SUBJECT: Forwards Burns & Roe review of BNL comments re effects of
 desynchronization methodology used in generic & plant-unique
 chugging load specs, per Mark II owners group 820209 meeting.
 Structural responses not significant.

Subject: NUCLEAR PROJECT NO. 2
DESYNCHRONIZATION METHODOLOGY
IN CHUGGING LOAD SPECIFICATION

REVIEW OF PROF. BIENKOWSKI'S CONCERN REGARDING
EFFECTS OF DESYNCHRONIZATION ON
THE CHUGGING LOAD SPECIFICATION USED
FOR WPPSS - NUCLEAR PROJECT NO. 2

Fig. 3a-1:

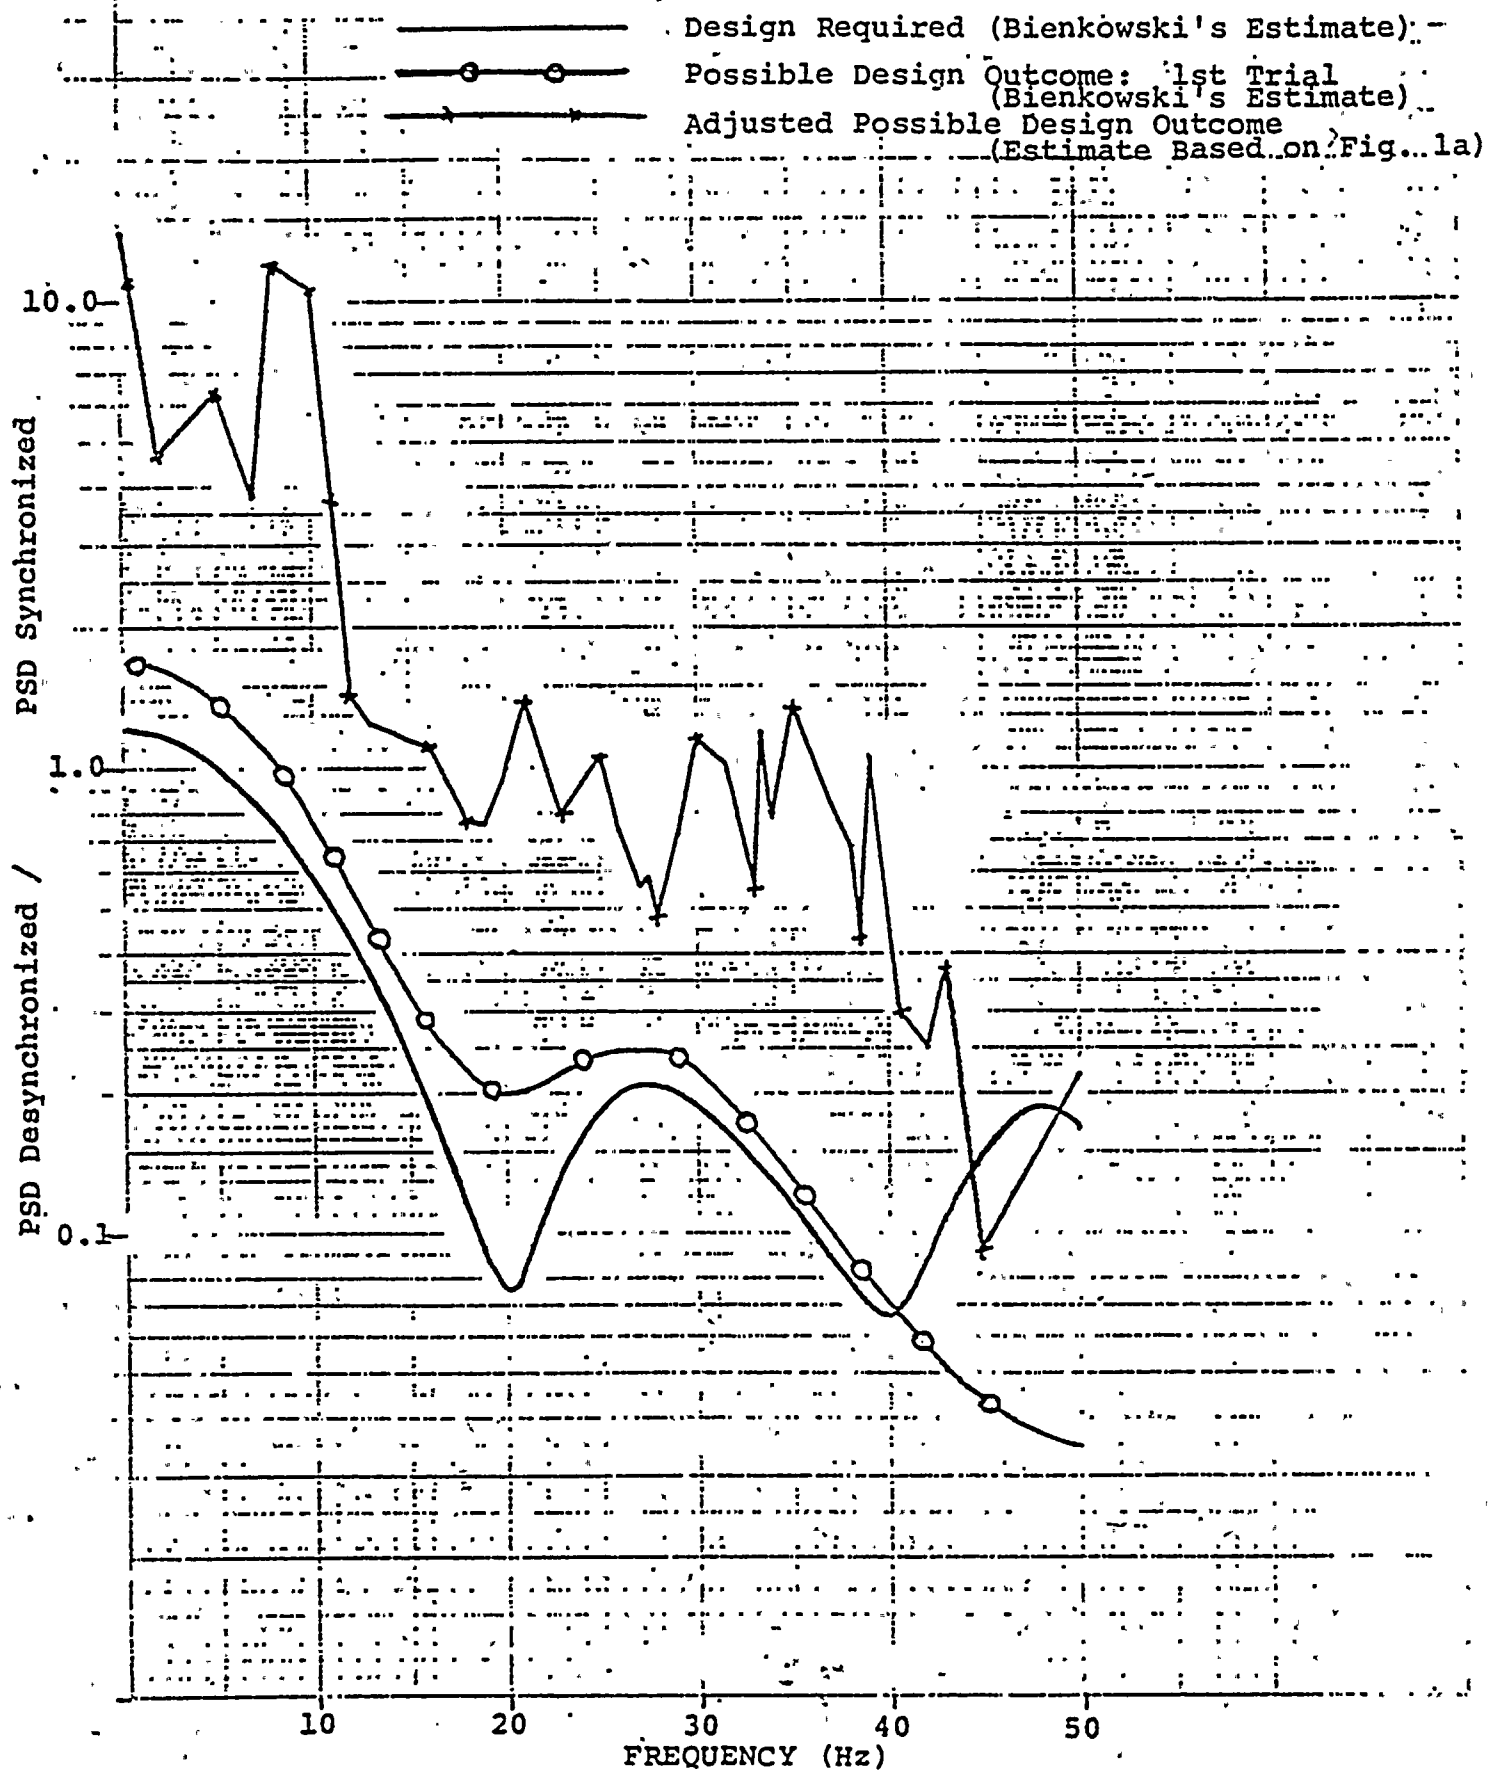
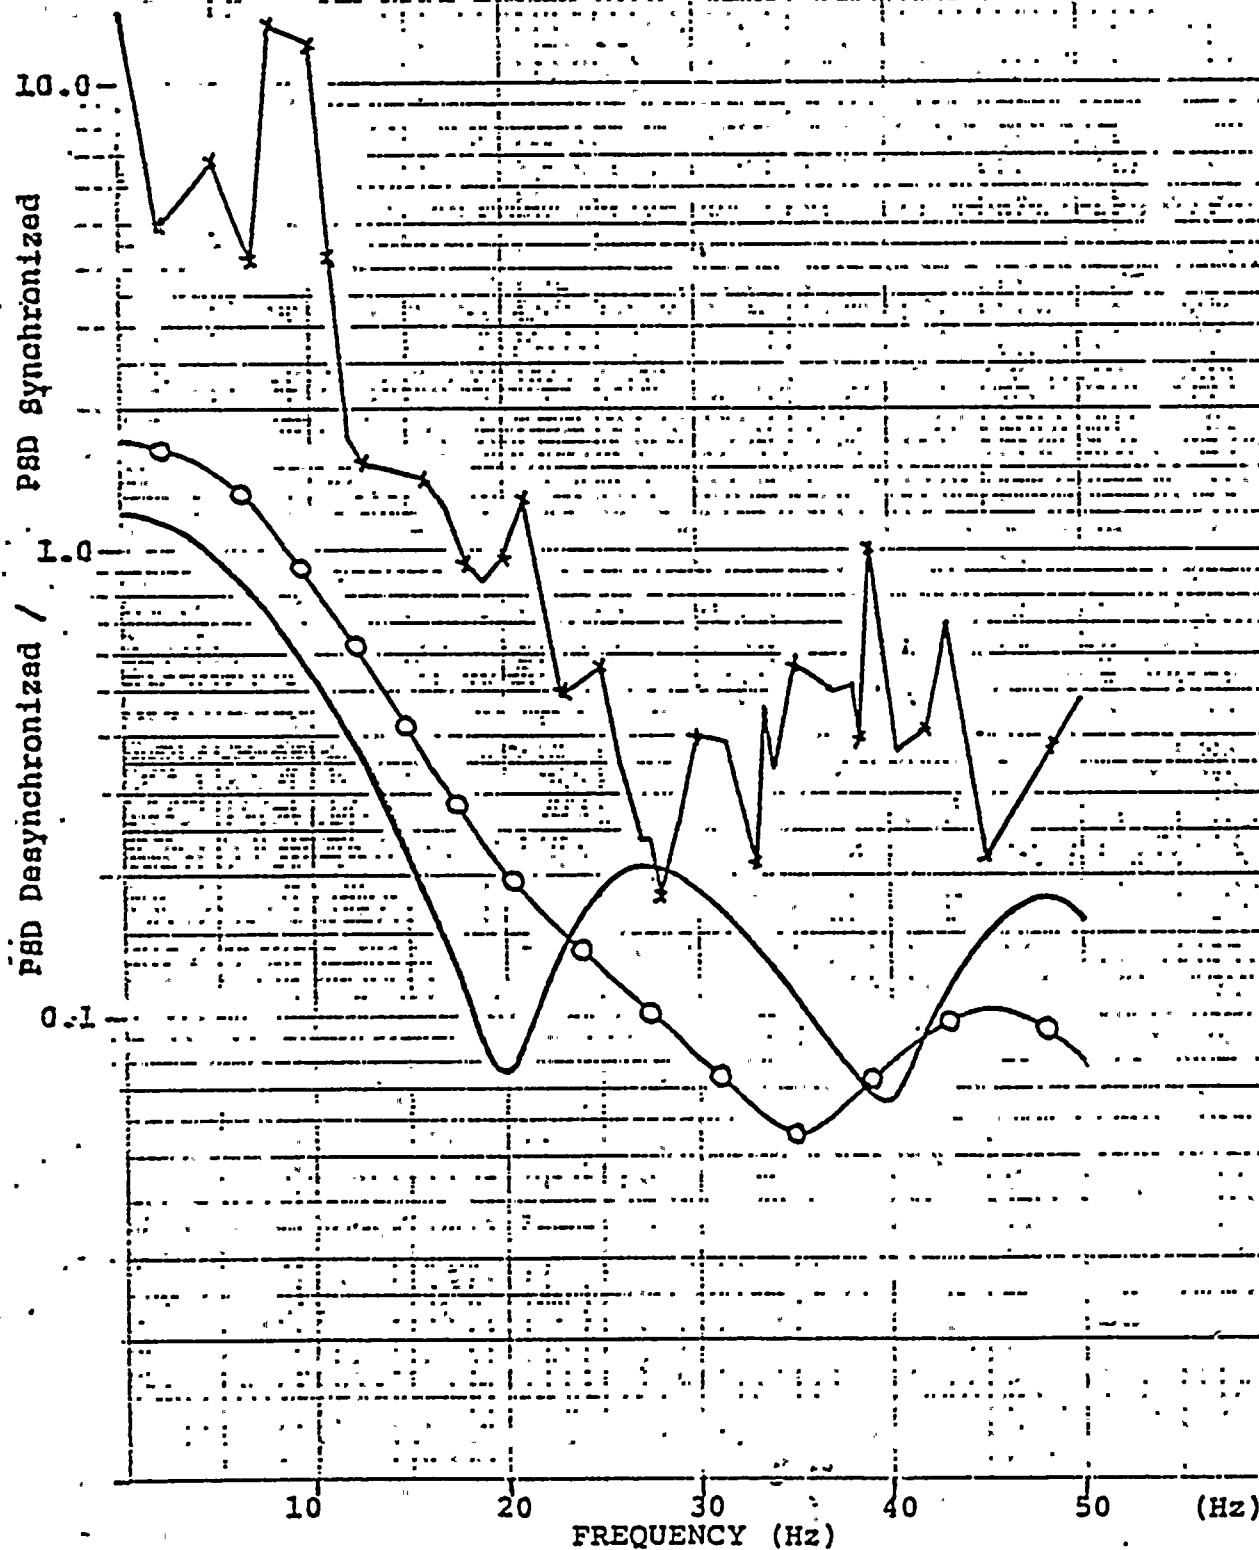
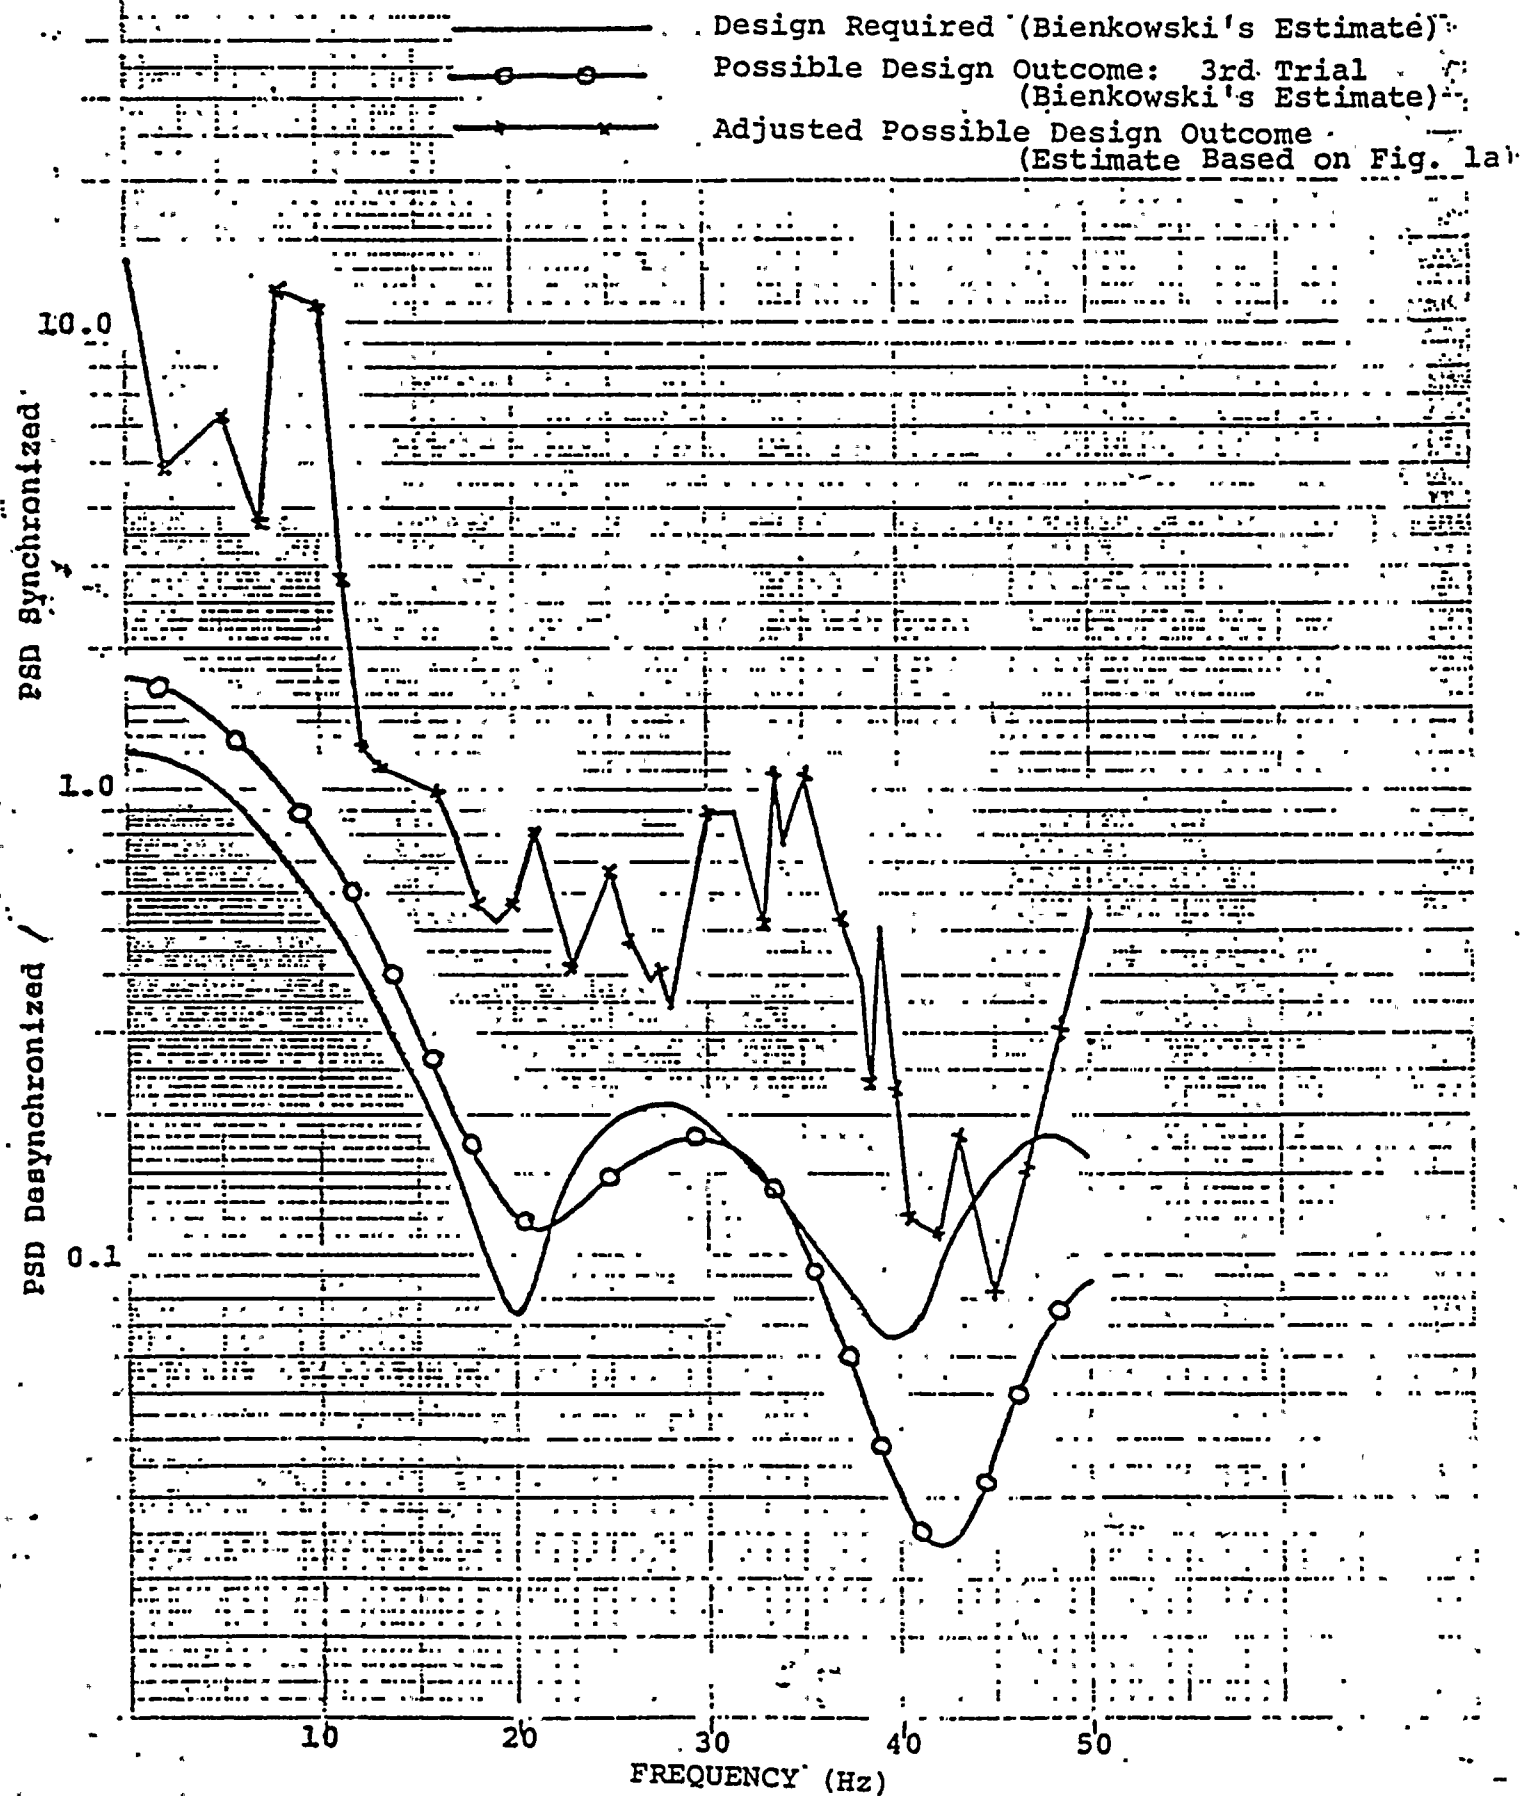
Prof. Bienkowski, as consultant to the NRC, has reviewed the effects of desynchronization on the chugging load; specifically he evaluated the sensitivity of the frequency content of the load to the selection of a single set of start times recommended by the load specification.

Starting, on the basis of "physical" intuition (actually rather historical precedence and practical considerations), with the vertical force and overturning moment acting on the suppression pool bottom as parameters that adequately describe the "major" structural excitations and using the results of calculations based, by necessity, on simplifying assumptions, Prof. Bienkowski reached the tentative conclusion that the desynchronization specification may result in frequency "holes" at some frequencies, mainly in the 20 Hz to 50 Hz range. It thus appears that the present chugging load specification may be deficient in this frequency range.

B. As discussed earlier in this letter-report the single-vent design "source" loads derived for application to WNP-#2 enveloped the 4TCO test data base by a good margin (see Figure 1). When this conservatism in design loads is duly accounted for, the desynchronization methodology used with the chugging load definition is shown to be adequate. Indeed, Figure 3 shows a comparison, frequency by frequency, for WNP-#2 vertical force in terms of the ratio = (PSD for-desynchronized application/PSD for synchronized application) between:

- a) required design values (or "true" bound of 1000 Monte Carlo trials) estimated by Prof. Bienkowski,
- b) (three) possible design outcome values (Prof. Bienkowski's estimates), and
- c) the same (three) possible design outcome values adjusted to account for conservatism in single-vent design "source" load definition.

As seen from Figure 3, when adjusted for conservatism in the design load definition, the possible design outcome values envelope by a good margin the required design values.

It should be noted here that the comparisons of Figure 3 are only estimates since the analytical procedures implemented on WNP-#2 (including software package) were not available to Prof. Bienkowski for use. It is believed that if these analytical procedures were to be used the comparison will be even more favorable.

It is therefore concluded that the present chugging load specification (including desynchronization) is adequate.
